Request for Information (“RFI”)

Harrison, Town-Village Recreation Center Phase 2
270 Harrison Avenue
Harrison, NY 10528

#033

Regarding: GYM CURTAIN WALL & RTU-2 SUPPLY DUCT

SHEET NO.
M3

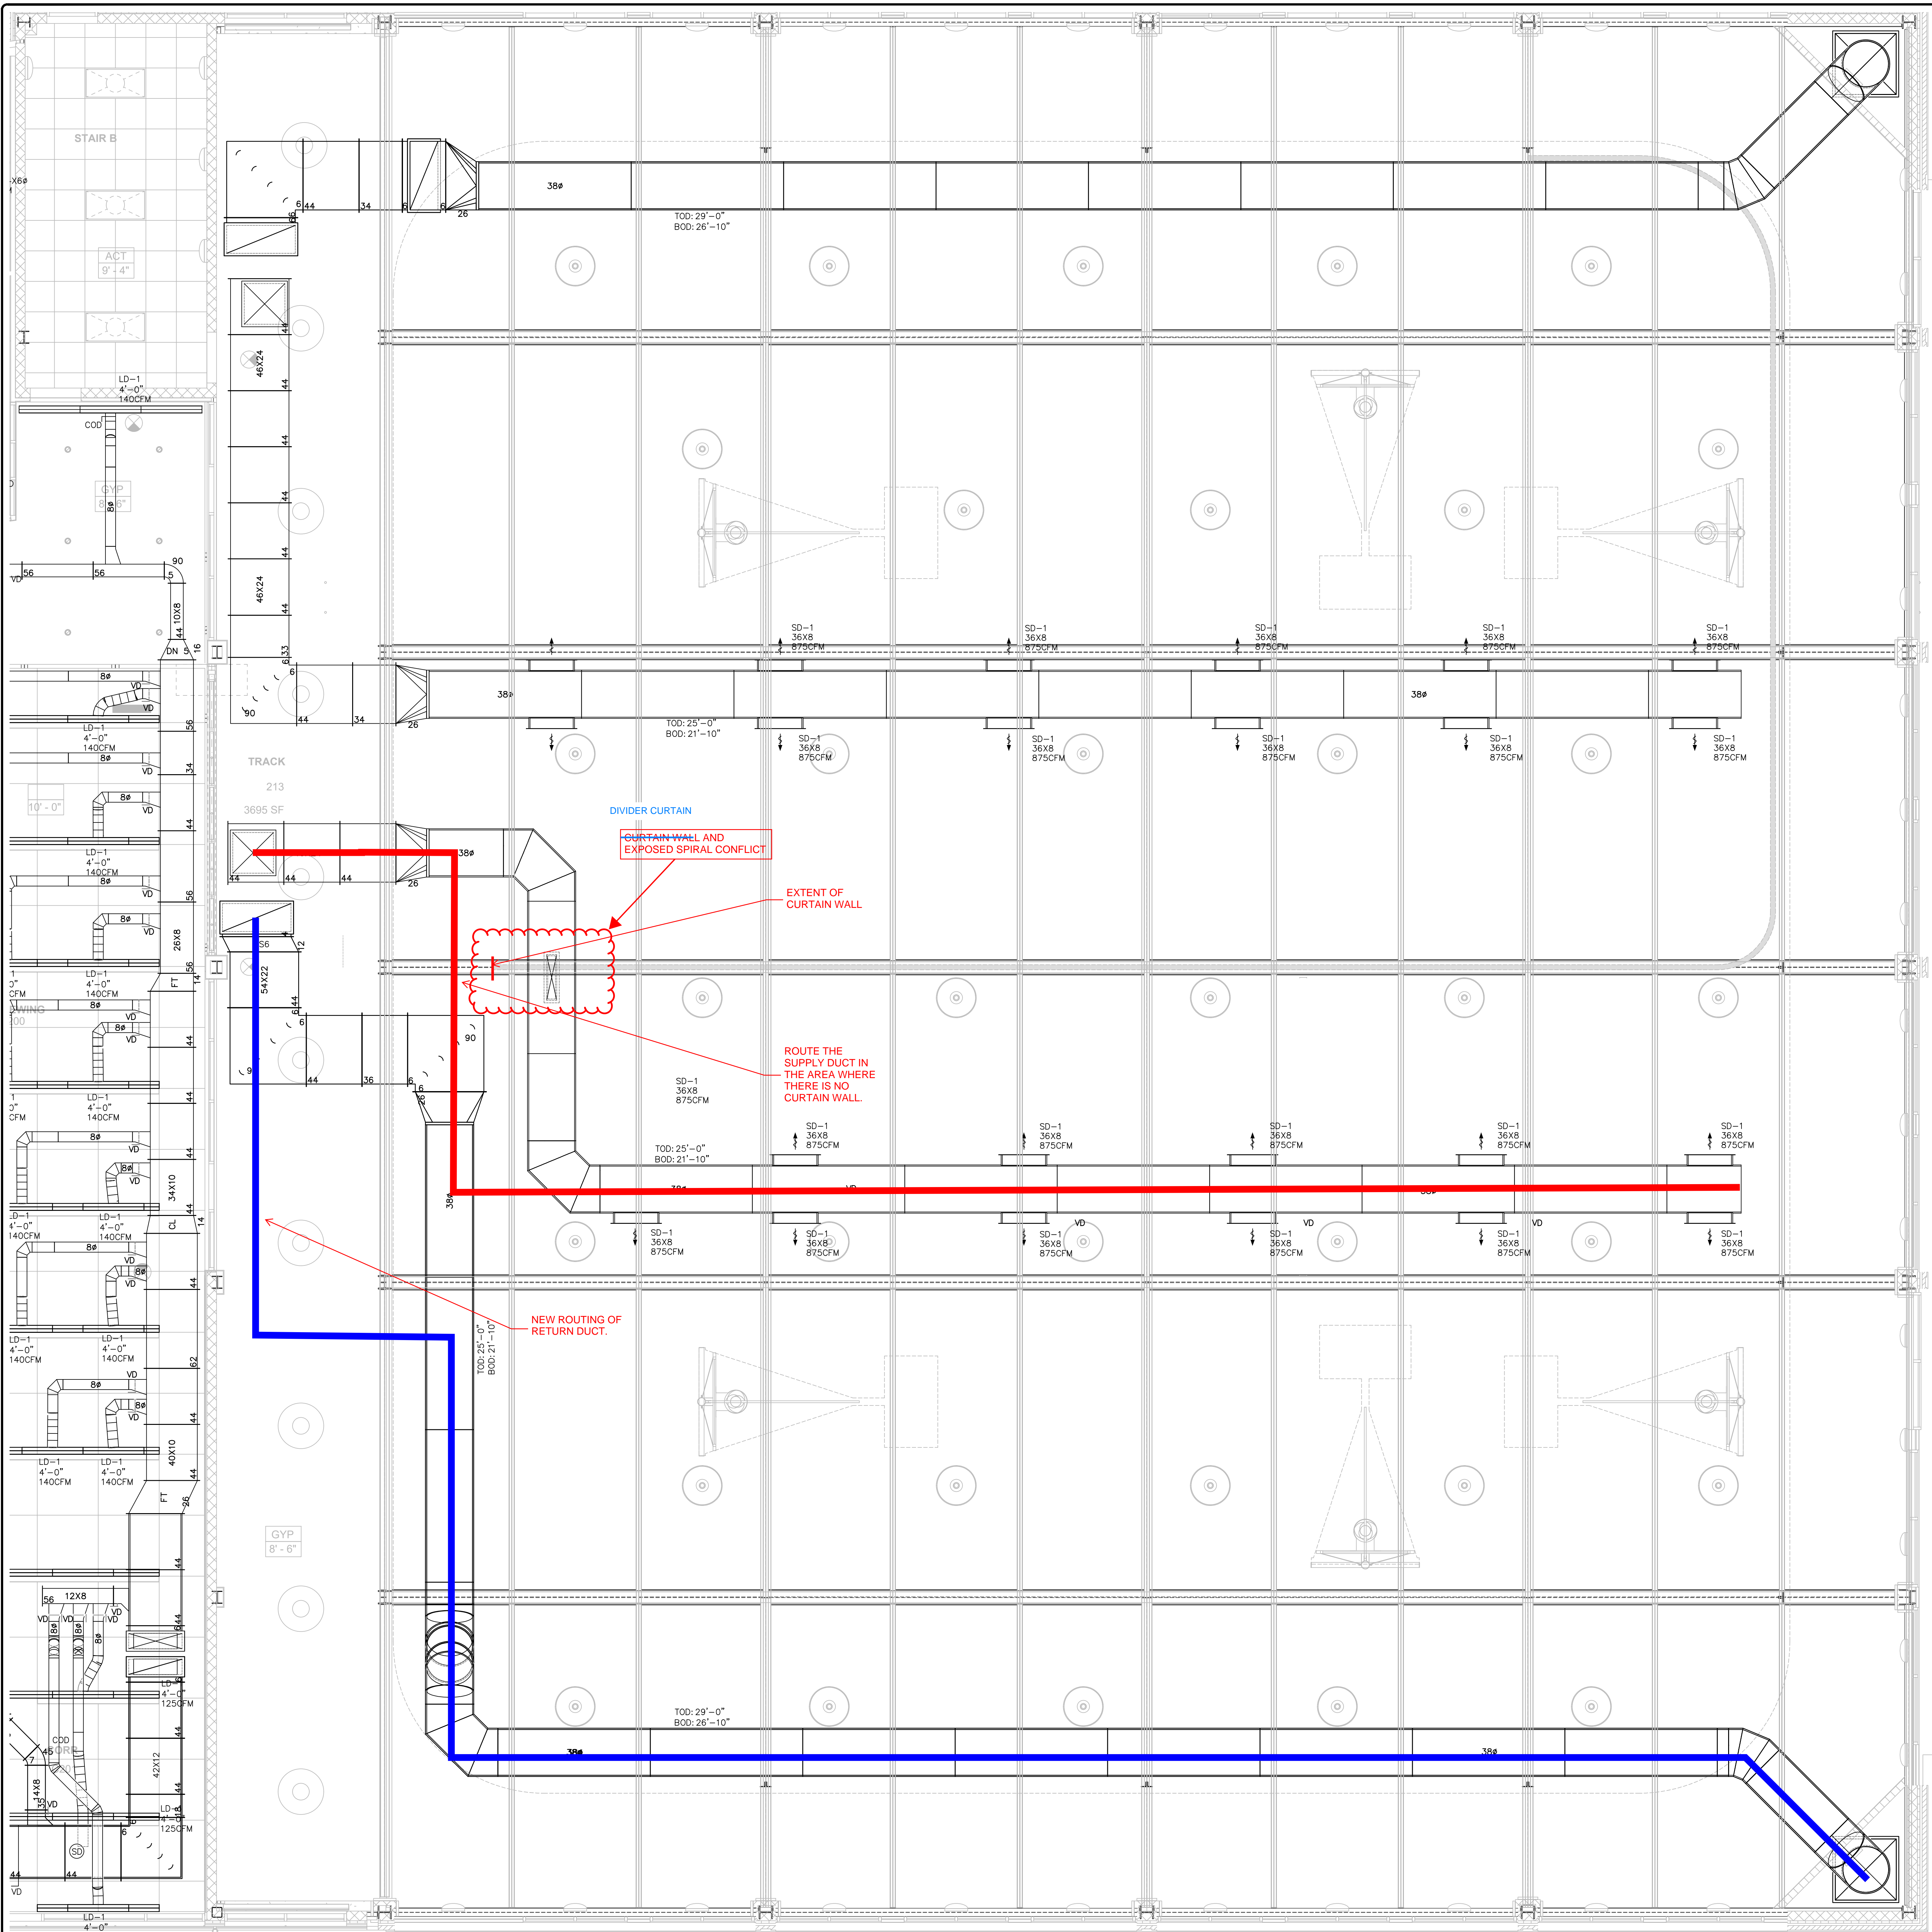
Please see the following RFI raised by Taconic HVAC regarding the conflict encountered between the RTU-2 supply duct and the Gym curtain wall and advise on how to proceed.

There is a conflict between the exposed supply spiral duct from RTU-2 and the curtain wall in the Gym. The spiral is currently shown just below the trusses in this area. I have attached a preliminary shop drawing for the Gym area for reference. All heights are taken off the gym floor. Please review and advise on how to proceed

OLA Response 02-19-2025:**Refer to revised routing on page 4.**

REVISED DUCT ROUTING
ACCEPTABLE- KGD
